HISTORIC DISTRICT REVIEW BOARD WORK SESSION AGENDA

Agenda Item: Application for new Construction, HDRB #25-005

Agenda Item: Application for an Alteration, HDRB #25-011

Agenda Item: APPLICATION FOR AN ALTERATION, HDRB #25-011, to consider a Certificate of Appropriateness to modify the front entrance of the building at 783 Station Street, Suite A, Herndon, Virginia, located on the northeast side of Station Street between the intersections with Pine Street and Lynn Street. The subject property is further identified as Fairfax County Tax Map 0162 02 0301D, is zoned PD-D Planned Development – Downtown District and consists of 5,904 square feet of land. Applicant: Michael Wijdoogen, MW Architects, LLC. Property Owner: James Building Development, LLC.

Greenhouse Site

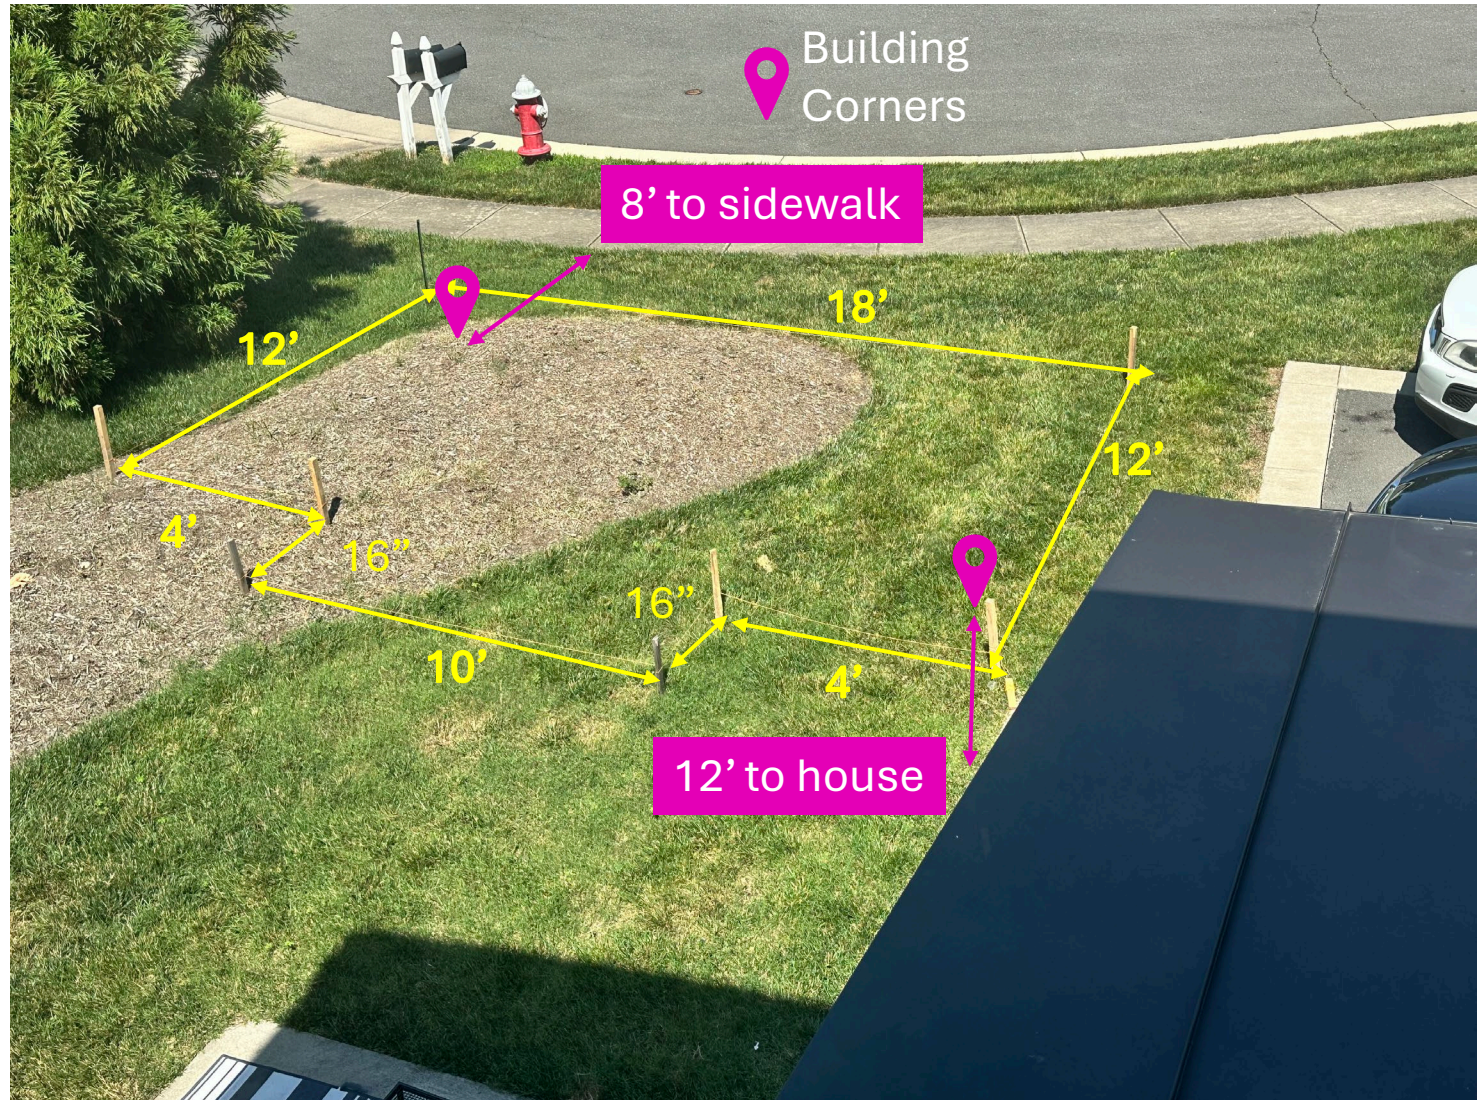
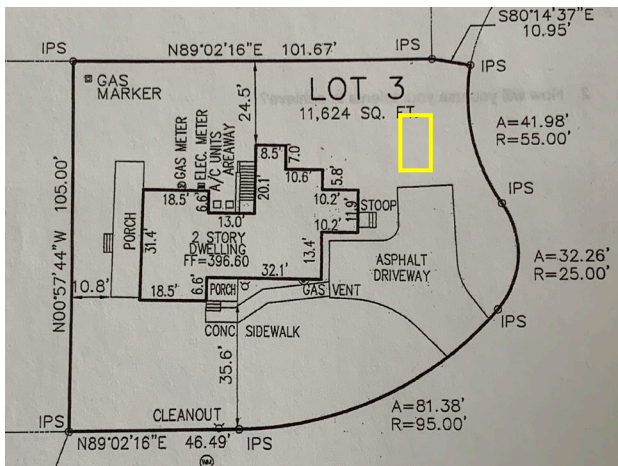
- The proposed location for the prefabricated accessory structure is highly visible from the Monroe Street right-of-way. Due to the lot configuration of this subdivision, there are no viable locations for siting the accessory structure on the subject property that is completely obscured from the right-of-way.

- o *The HDRB should discuss the appropriateness of siting the accessory structure along Monroe Hill Court given the site constraints.*
- The applicant should provide materials specifications for the roof material and windows of the proposed greenhouse (see below).

- Material description and/or specifications for the transparent roofing material
- Material description and/or specifications for the greenhouse windows

1. The applicant shall provide updated application materials documenting the material specifications of the accessory structure's roofing and windows for staff approval and for inclusion in the case record.

SHEET NUMBER: **A1.0**

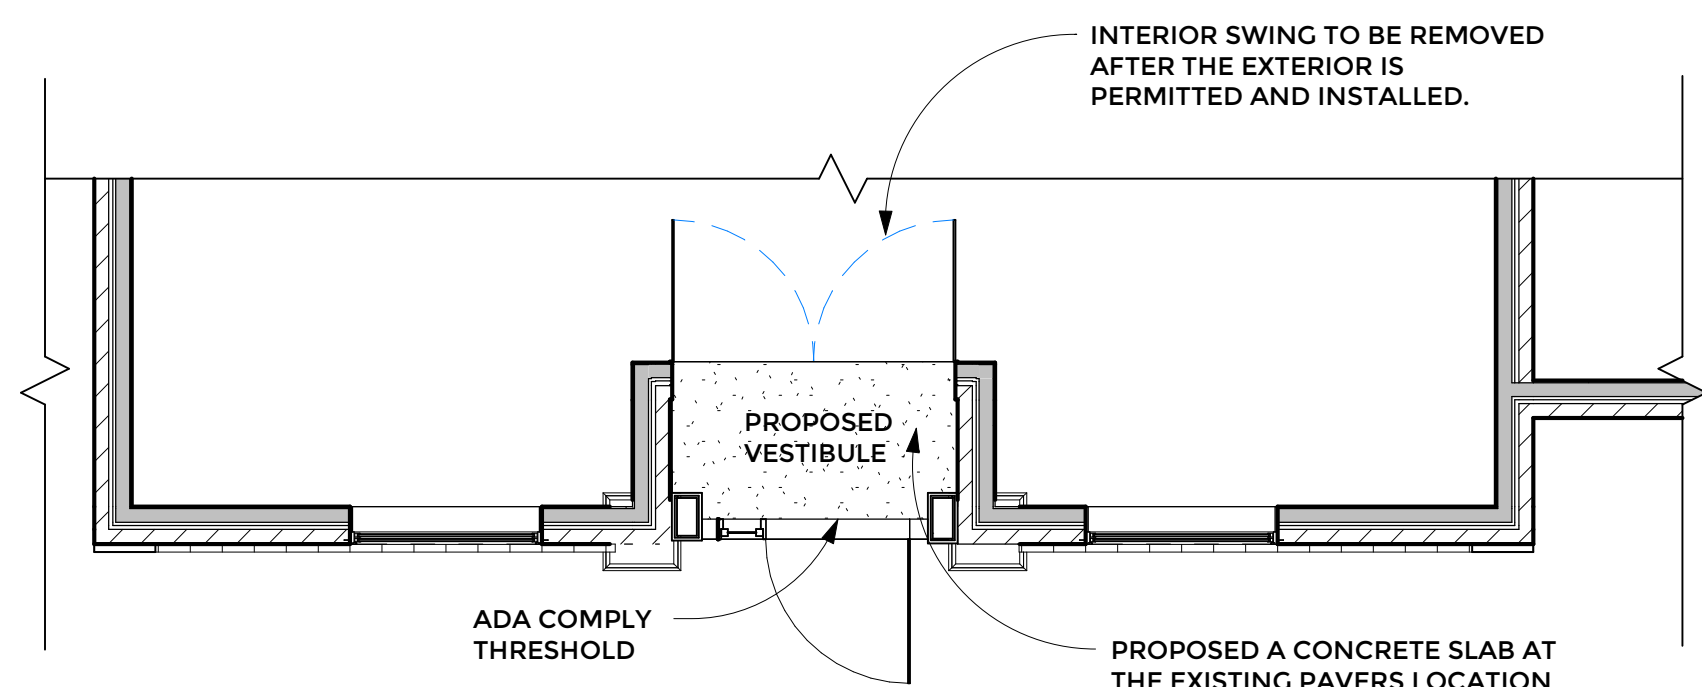
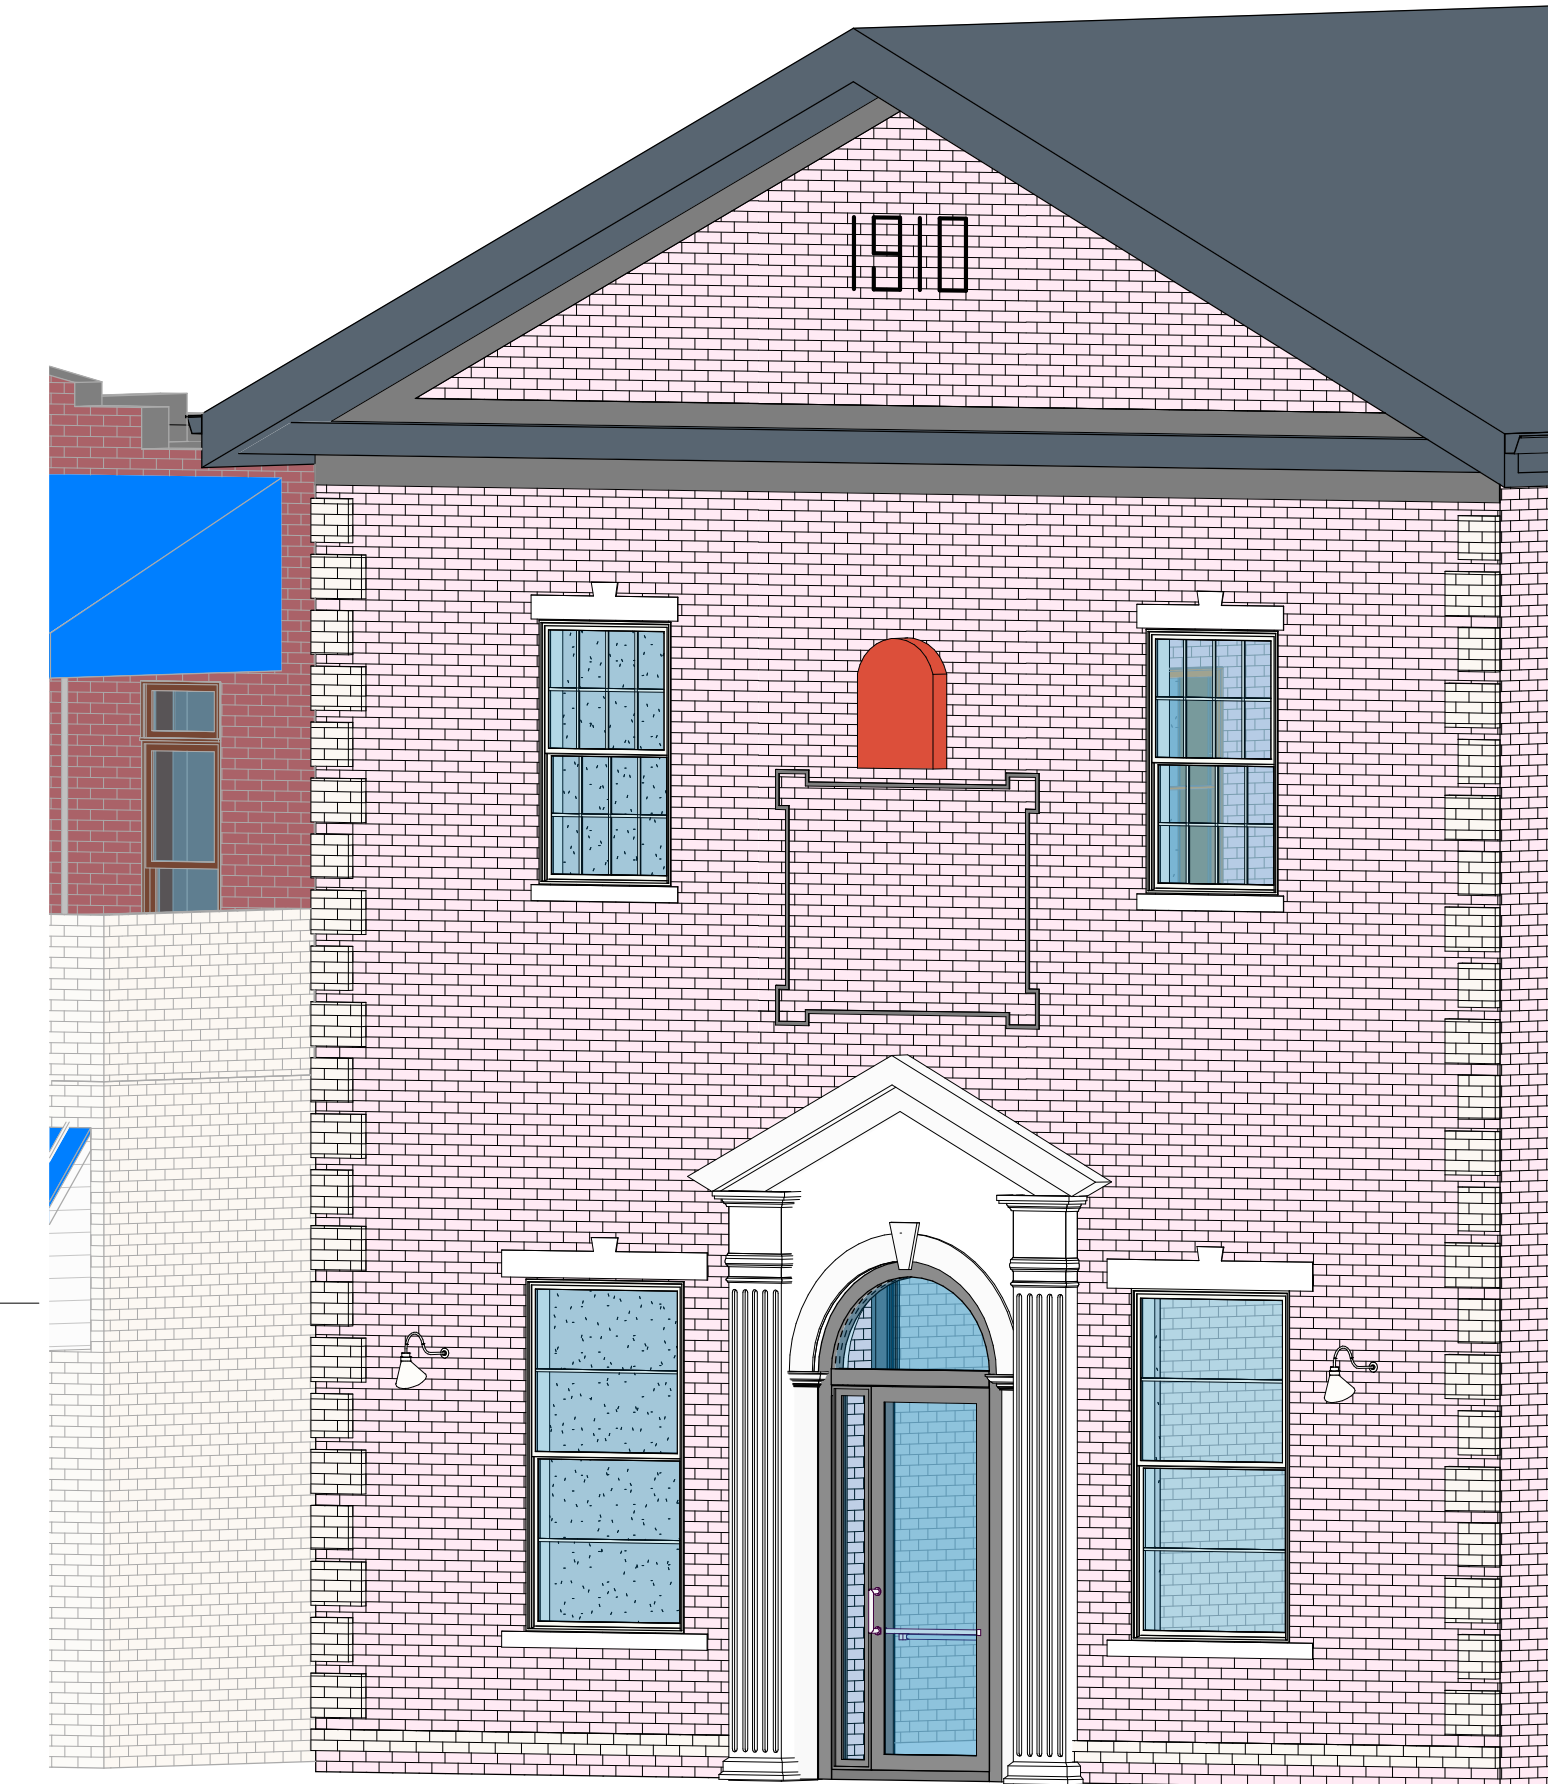
- o The current proposal does not maintain a symmetrical arrangement along the façade due to the use of only one sidelite on the left side of the system (when viewed from the right-of-way facing northwest).

- Staff are requesting additional information pertaining to the placement of the proposed door system to better understand how the proposal will impact extant historic material and the overall design of the façade. As noted above, the proposed design will negatively impact the symmetrical arrangement of the

- Staff recommend the applicant seek a design option that will maintain the building's symmetry.
- Furthermore, staff recommend that the door be recessed within the entryway to the same extent that the current door is to minimize the visual impact of this non-historic design element on the contributing building at 783 Station Street. Depending on the extent the new door is recessed, an anodized black finish may be preferable to a clear (silver) anodized finish.

- In summary, staff recommend that the applicant:
 - Explore and potentially provide an option to recess the proposed aluminum framing system to more closely approximate the current position of the entry doors.

- Provide an option that uses traditional materials and detailing that would better complement the neoclassical detailing of the subject building than the aluminum framing does.

- Provide a design option that would preserve the symmetrical design of the building's façade.
